**LIMA WATER SYSTEM IMPROVEMENTS
CONTRACT 1: UPGROUND RESERVOIR
2009
ADDENDUM NO. 4
July 1, 2009**

ADDENDUM 4

FISH SPAWNING POINT DETAIL

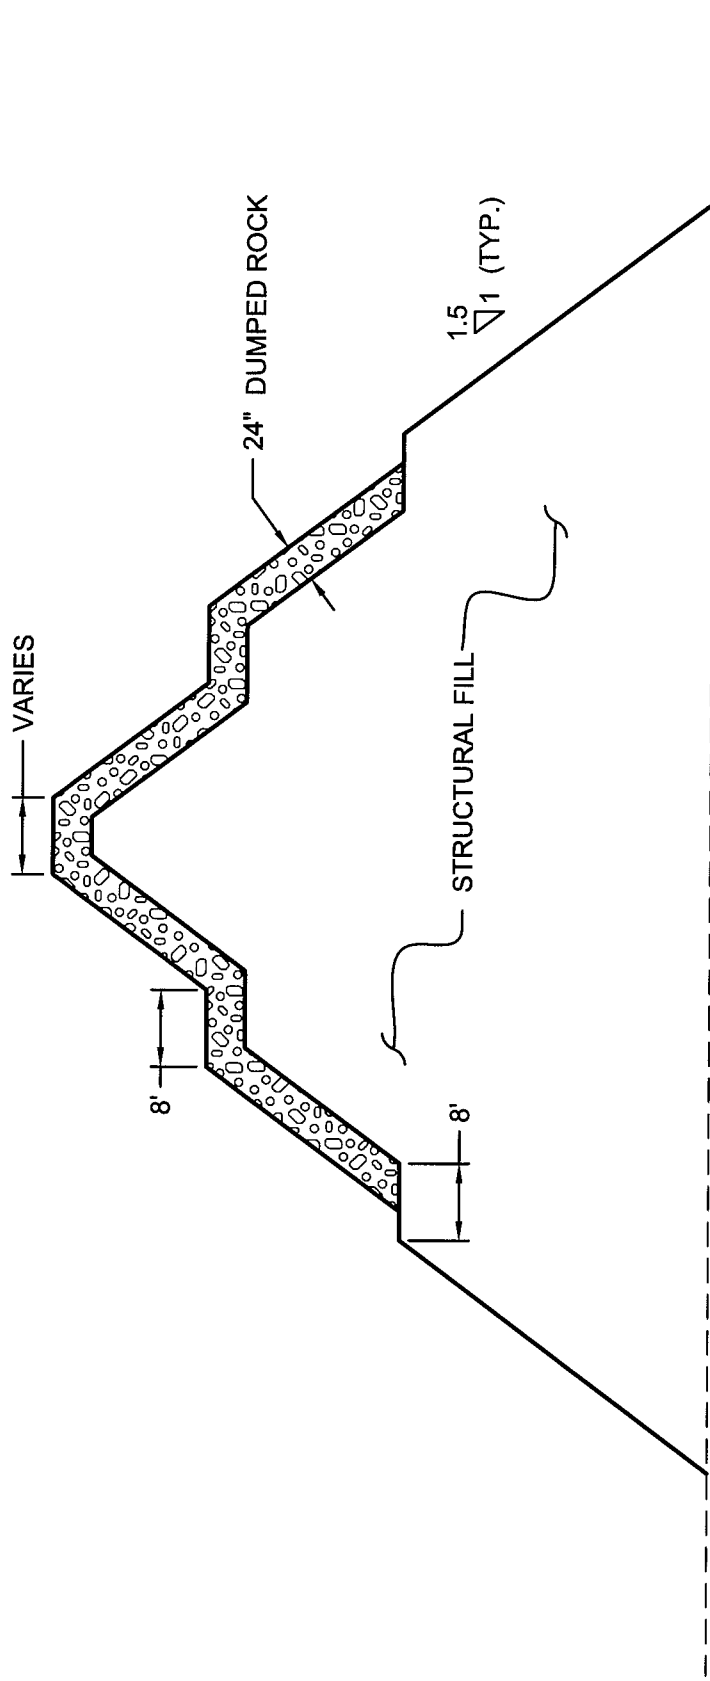
1. Plan Sheet C4.1 Manhole 15 – replace 6" E INV = 818.16 with 10" E INV = 817.82.
2. Plan Sheet C13. Fish Spawning Point Details. Revise the limits of Dumped Rock as shown on the attached sketch. Dumped Rock is to continue around the nose of the Point.

NOTE: NOSE OF THE POINT IS SIMILAR.

ASPHALT PAVEMENT SECTION - PARKING LOTS, DRIVES,
 PAVED MANEUVER AREA, AND MAKE-READY AREA
 NTS

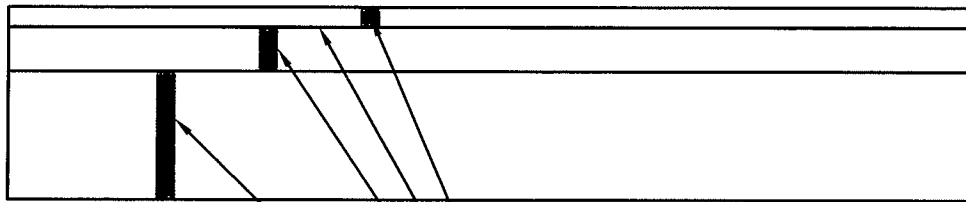
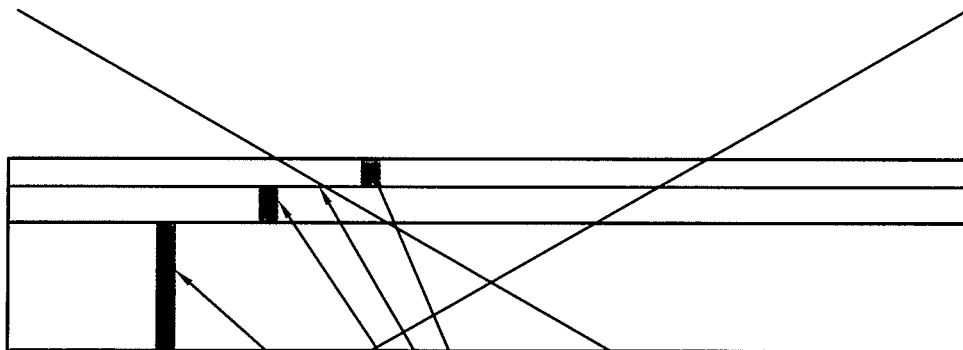
5. Plan Sheet C16. Replace two pavement sections with the one new section attached. This pavement section shall be used for parking lots, drives, paved maneuver area and make-ready area.

- 1 1/4" - ODOT ITEM 441, TYPE 1 SURFACE COURSE
- TACK COAT
- 2 3/4" - ODOT ITEM 441, TYPE 2 INTERMEDIATE COURSE
- 8" ODOT ITEM 304 AGGREGATE BASE

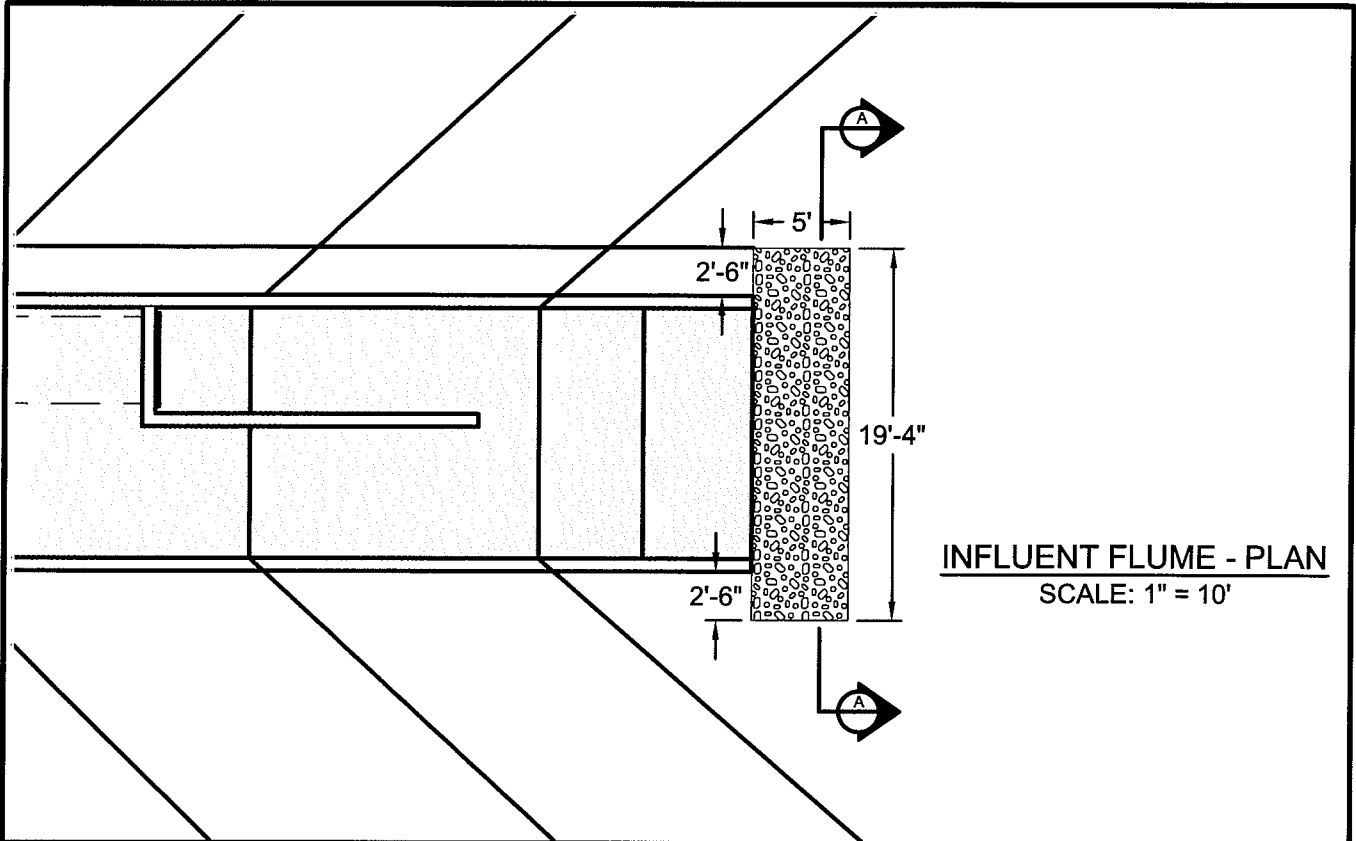
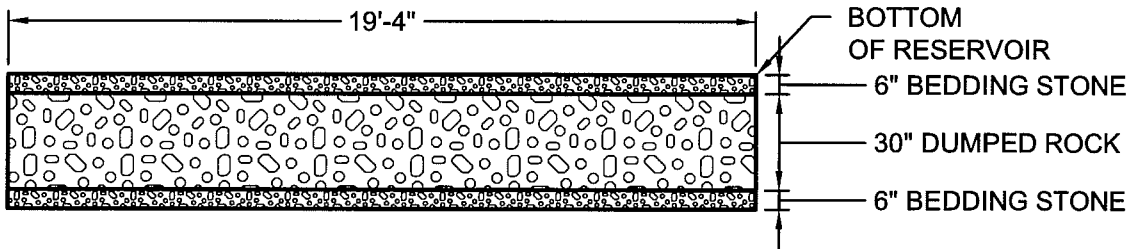
6. Plan Sheet C20. The riprap apron shown at the end of the influent channel is to be constructed as shown on the attached sketch.
7. Plan Sheet C21. The riprap aprons at the inlets of intake pipe are to be 8-feet wide, centered on the intake pipe. The aprons are to have 30 inches of Dumped Rock over 6 inches of Bedding Stone.

OVERFLOW HEADWALL RIPRAP

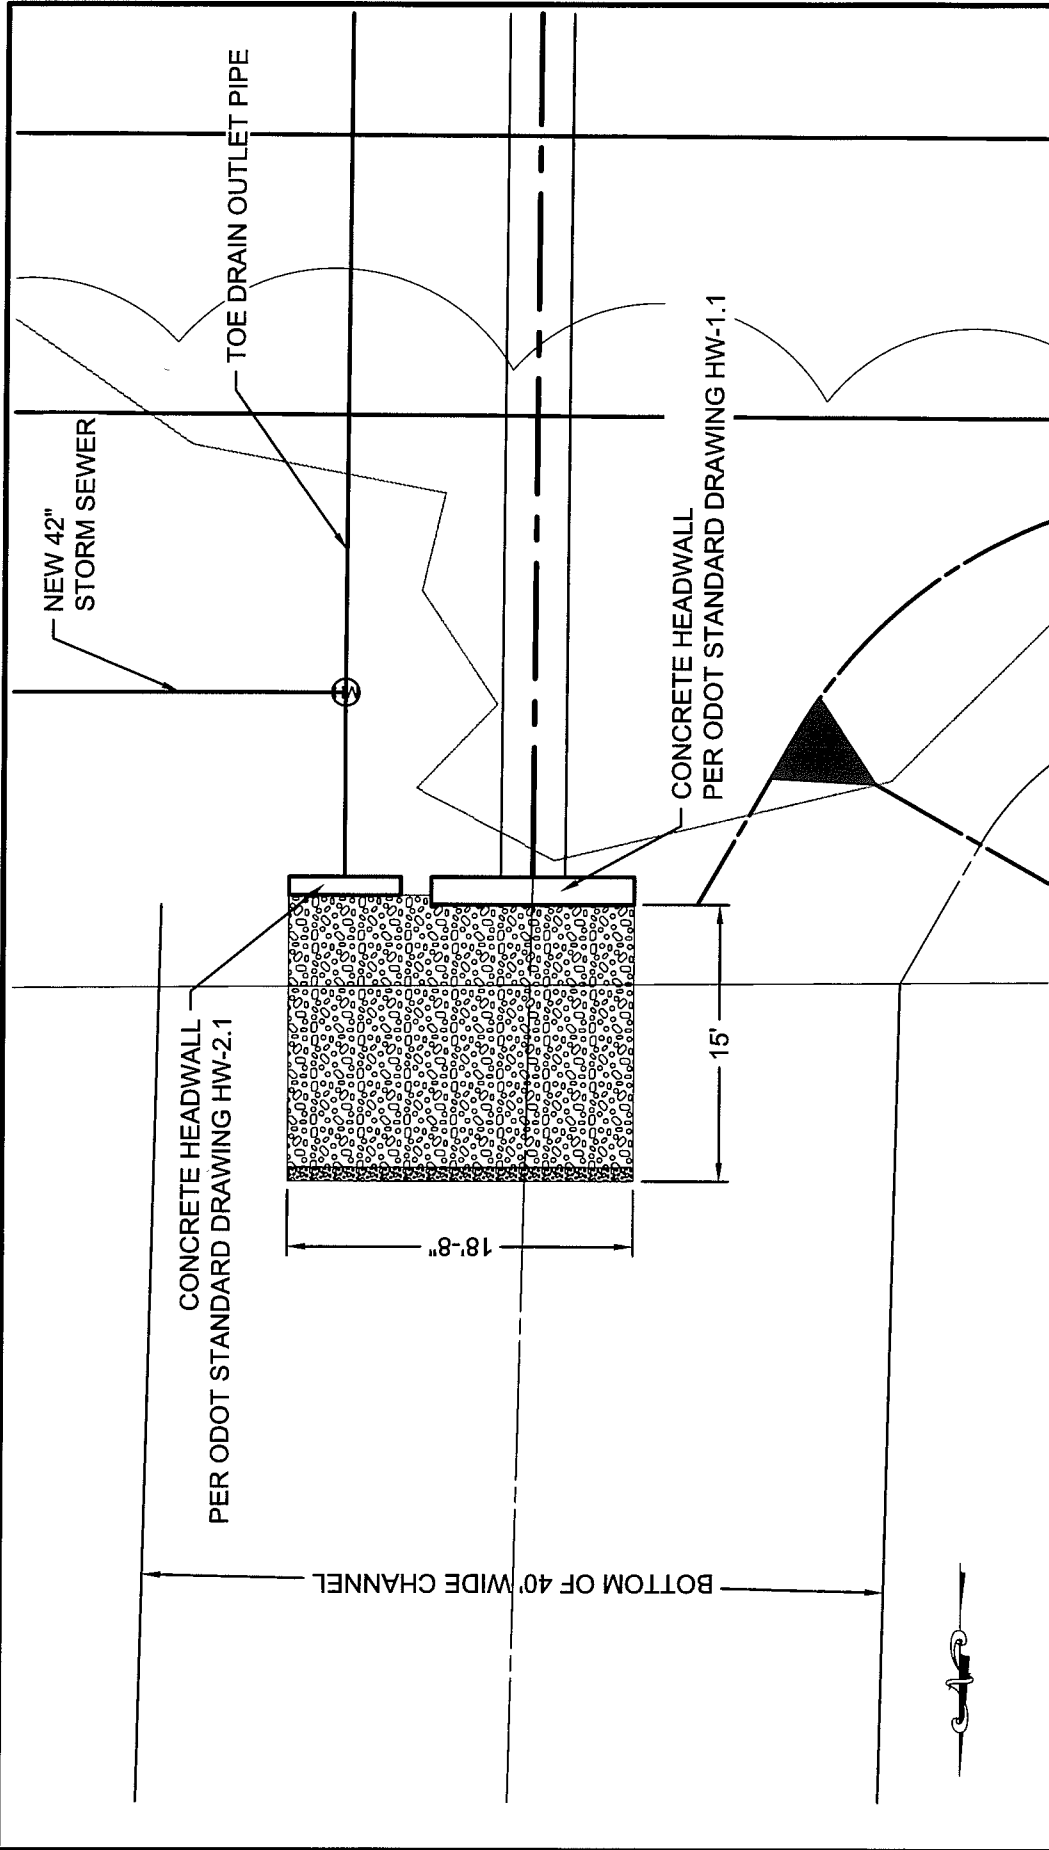
8. Plan Sheet C22. The riprap apron at the headwall is to be constructed as shown on the attached sketch. The riprap apron around the 8-inch diameter inlet pipe is to be 10 feet along the slope. Riprap is to be 30 inches of Dumped Rock over 6 inches of Bedding Stone.
